62 WOLSELEY ROAD, LONDON, N8 8RP: ECO HOUSE SCHEME

NON-MATERIAL AMENDMENT APPLICATION

PLANNING STATEMENT
MARCH 2023

1.Proposed site plan

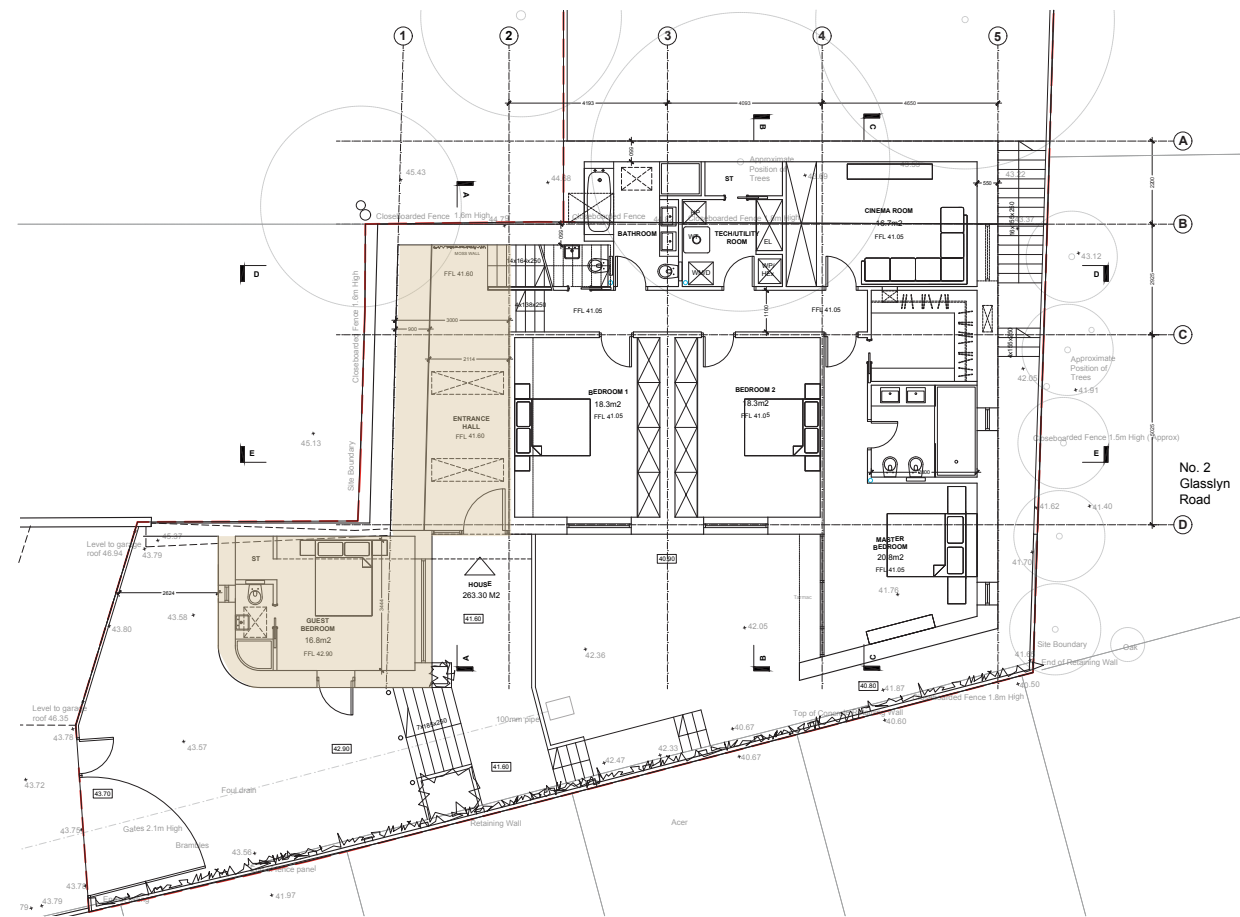
- 1.1. Increased Area: The application site has been enlarged by the addition of part of the rear garden of no.58 Wolseley Road, increasing the site area by an additional 42.75m2.
- 1.2. Rectilinear Shape: The rectilinear shape of the new application site has allowed new possibilities in the layout of the house, which has instigated revisions and improvements to the scheme.

5. Revised lower ground floor plan
(Drawing number: 591-110-P2)

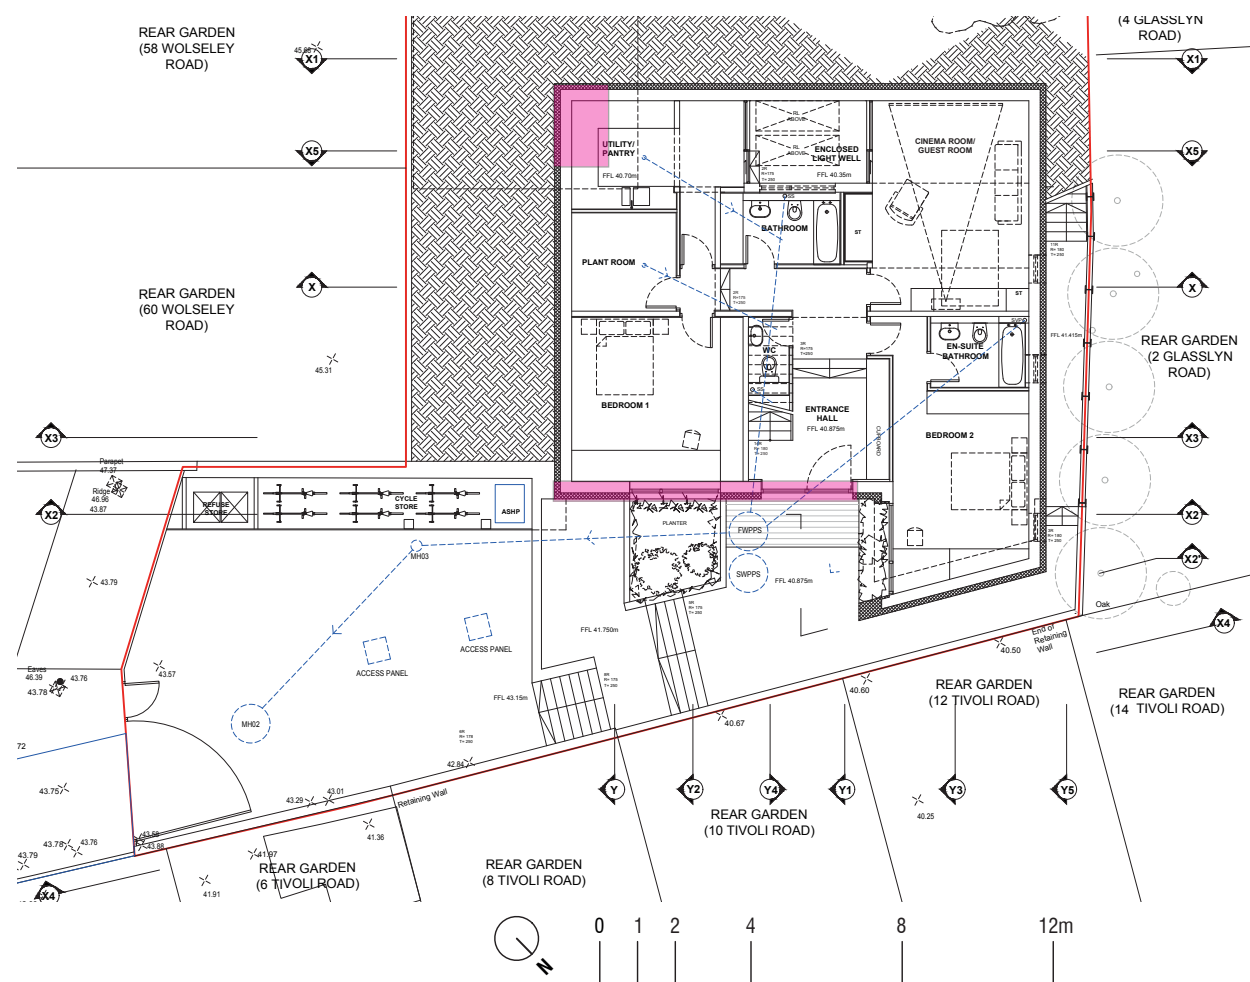
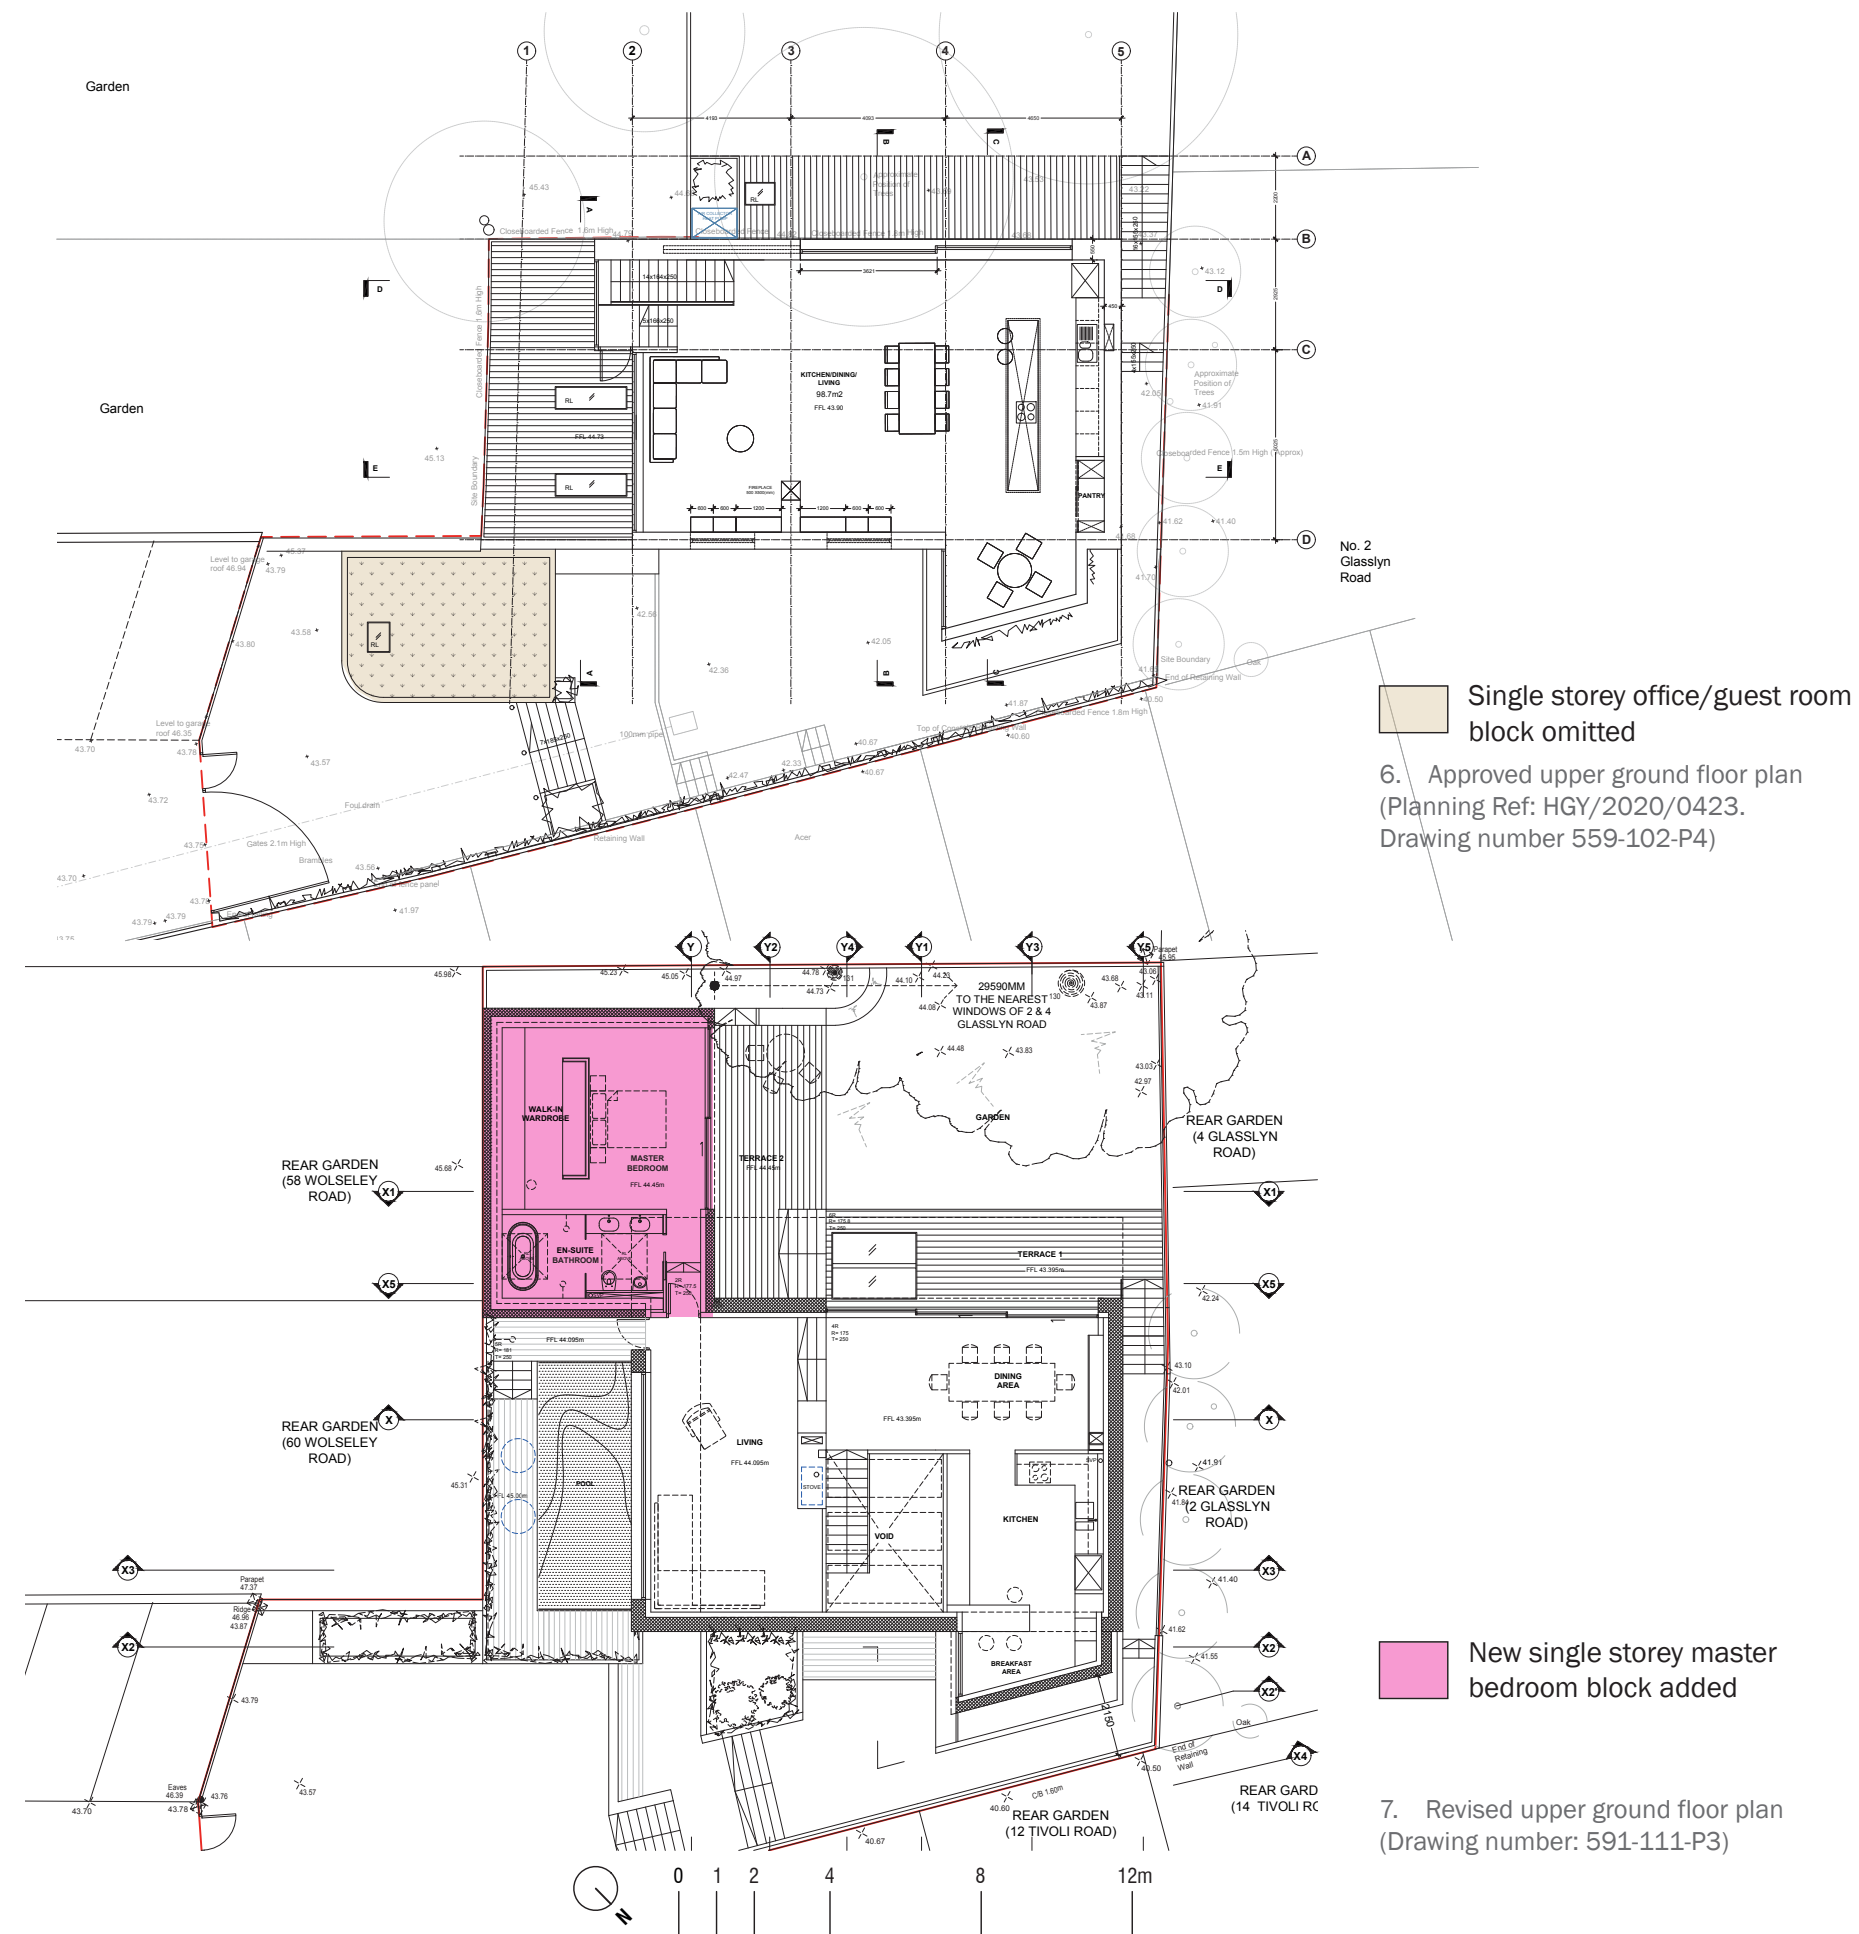
- 2.1. Reduced Area: The size of the lower ground has been reduced by removing the part of the basement section adjacent to 60 Wolseley Road. This has resulted in a reduction in lower ground floor area of 22.75 m2.
- 2.2. Reduced Construction Cost: The change in the basement to a rectangular shape has enabled cost savings, by reducing the length of retaining wall and requiring less excavation.
- 2.3. Reduced Impact on Neighbours: By moving the basement retaining walls away from the site boundary with nos. 58 and 60 Wolseley Road, any disruption to neighbours that could result from the building works will be significantly reduced.

8. Revised upper ground floor plan in relation to the existing buildings at 58 and 60 Wolseley Road and 2 and 4 Glasslyn Road

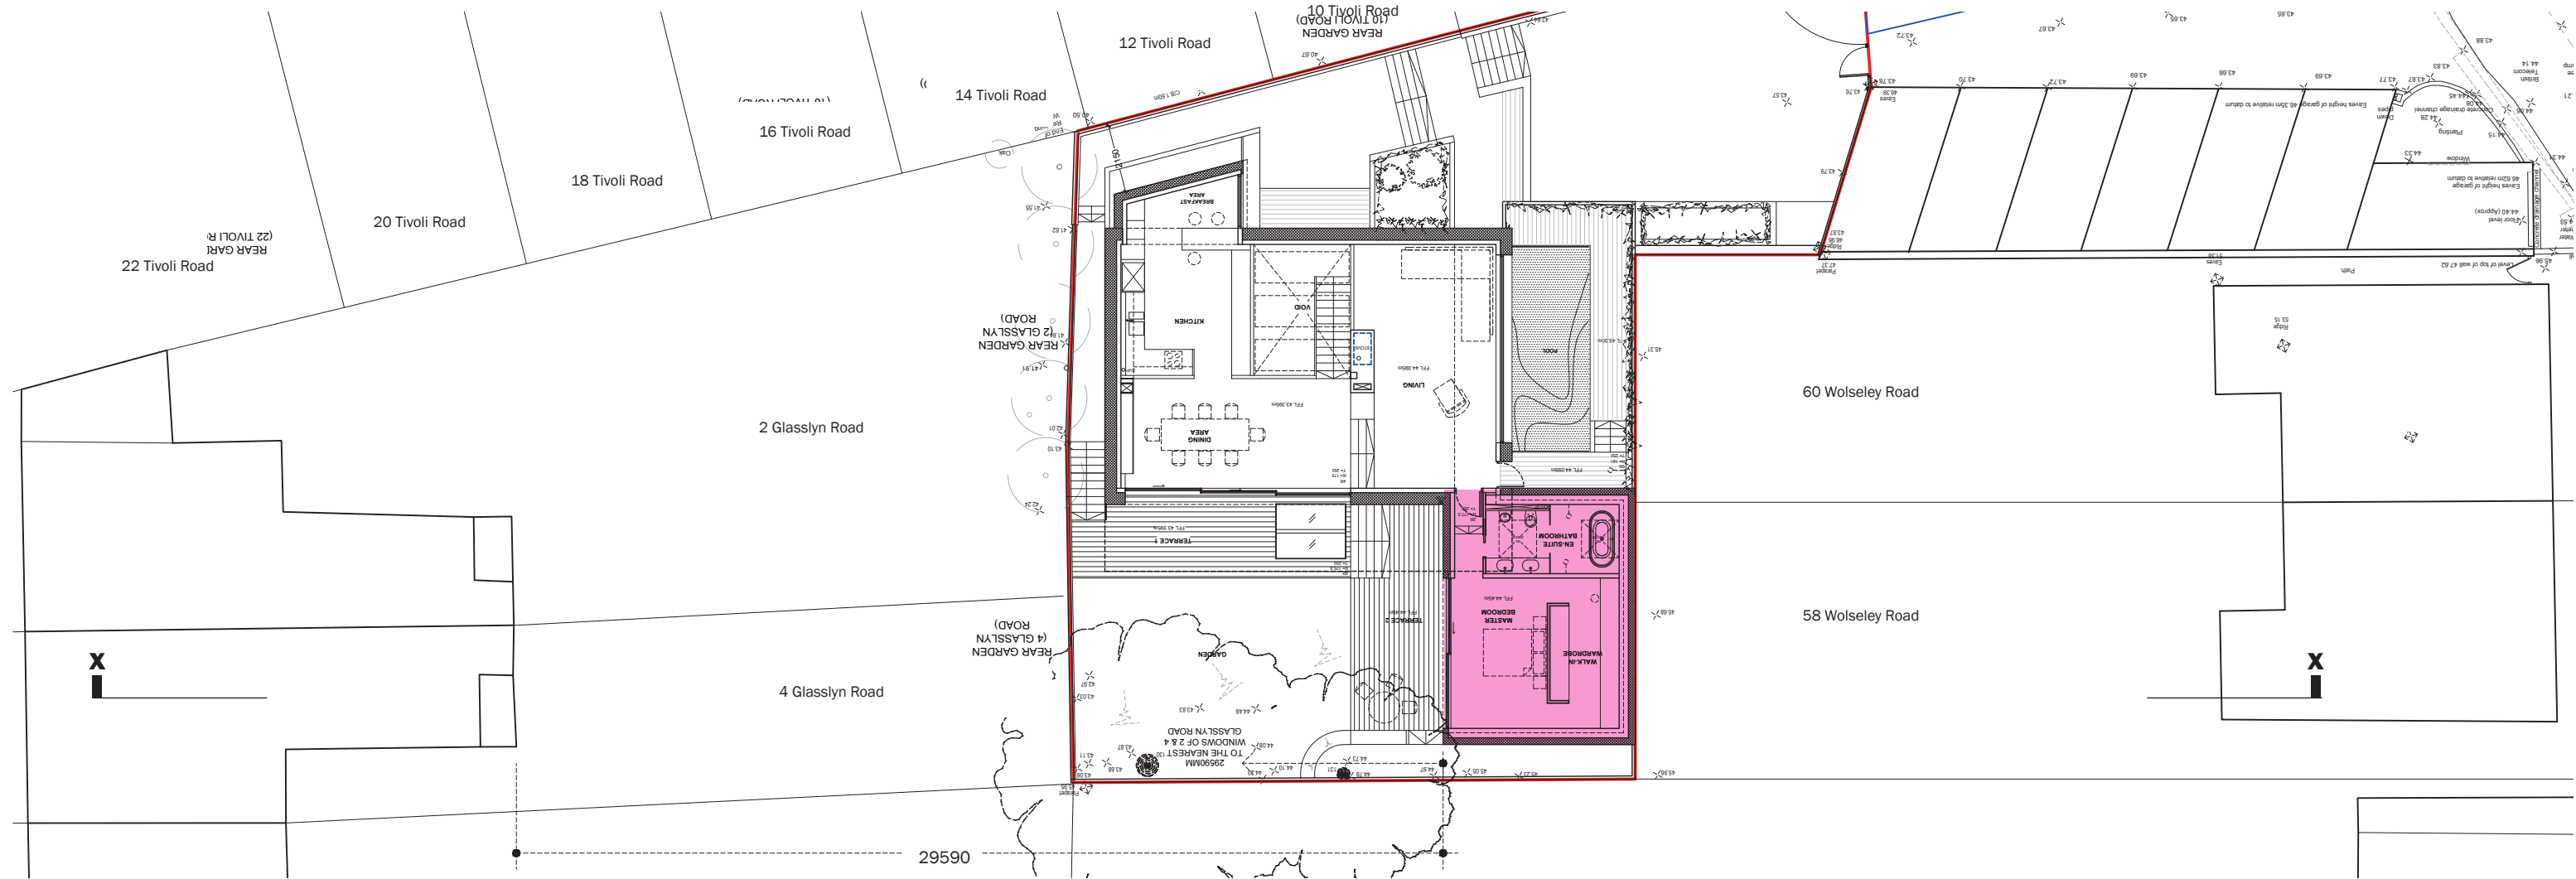
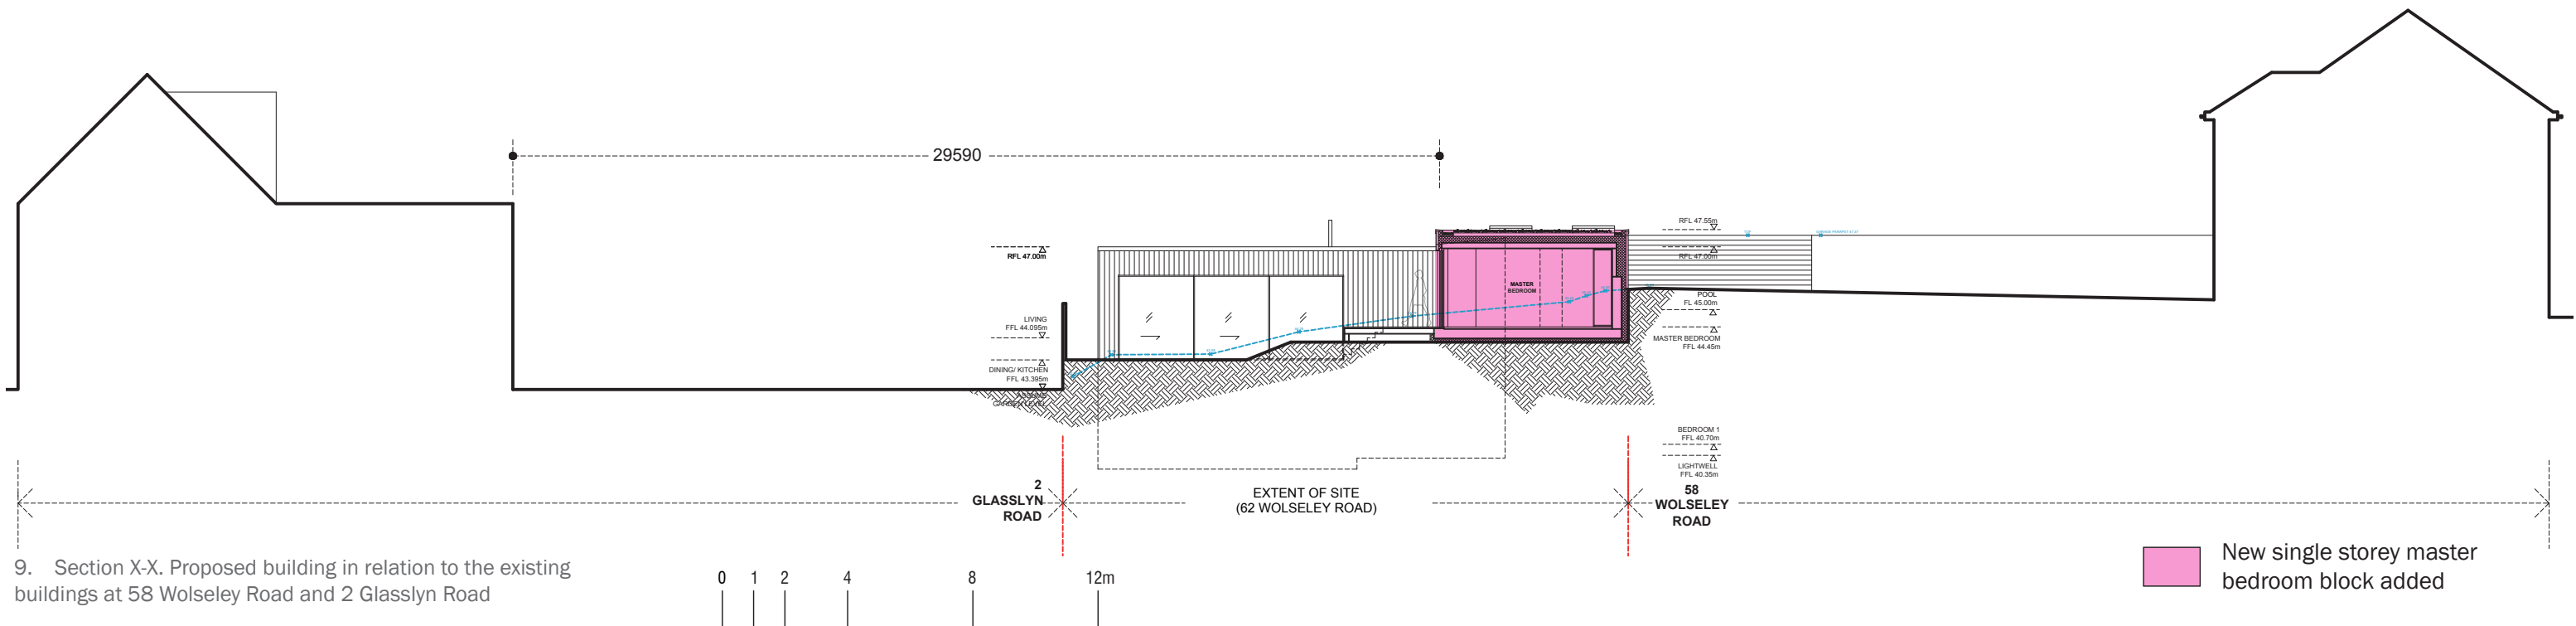
- 3.1. Relocation of Detached Block: The separate Office/Guest block that, in the approved scheme, was located in the Entrance Court, is to be moved to the rear of the site overlooking the amenity space with a slightly enlarged footprint, resulting in a total increase of 15.25 m².
- 3.2. Change of Use: The detached block, previously the Office/Guest bedroom, is now to be the Master Bedroom, which is an appropriate use for the quiet and secluded location at the rear of the plot.
- 3.3. Relationship to Neighbours: Although the Master Bedroom window faces the neighbouring houses in Glasslyn Road, the distance to the rear of nos. 2 and 4 Glasslyn Road is approximately 30m, so that there would be no overlooking or loss of privacy. (Refer to fig. 8, 9 & 10)
